Quanta Computer Inc.		
PROJECT : ZK6		
Size	Document Number	Rev
	Power switch Board	1A
Date: Friday, April 24, 2009	Sheet 1 of 1

Model	REV	CHANGE LIST	MODEL	ZK6	
				FROM	To

ZK6_Powerswitch board

top-emit LED

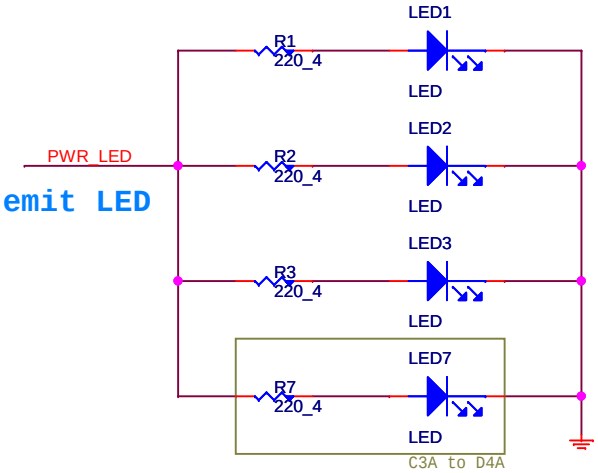
2009/02/05 item1 LED4,5,6 change Footprint , P/N
2009/02/06 item2 HOLE1,2,3 change footprint , h-c236d110p2 change to h-c236d106p2
2009/02/10 item3 add PAD1
2009/02/17 item4 CN1 change from DFFC06FR019 to DFFC06FR280

2009/03/11 item5 LED4,5,6 footprint change from<LEDLTST-S326KGJSKT-3P>to<ledltst-s326kgjskt-3p-nb4>

2009/04/22 item7 LED6 change Material and footprint

side-emit LED

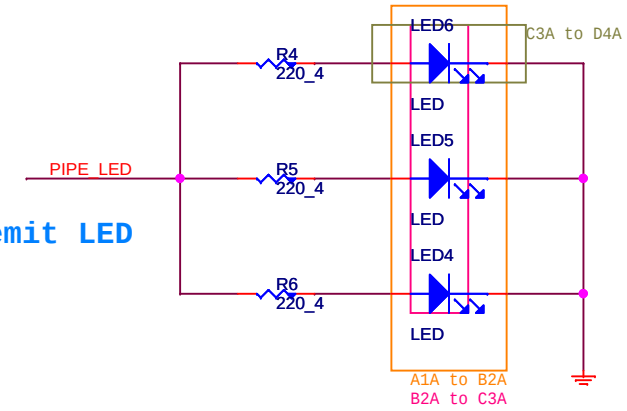
2009/04/22 item6 add R7 and LED7
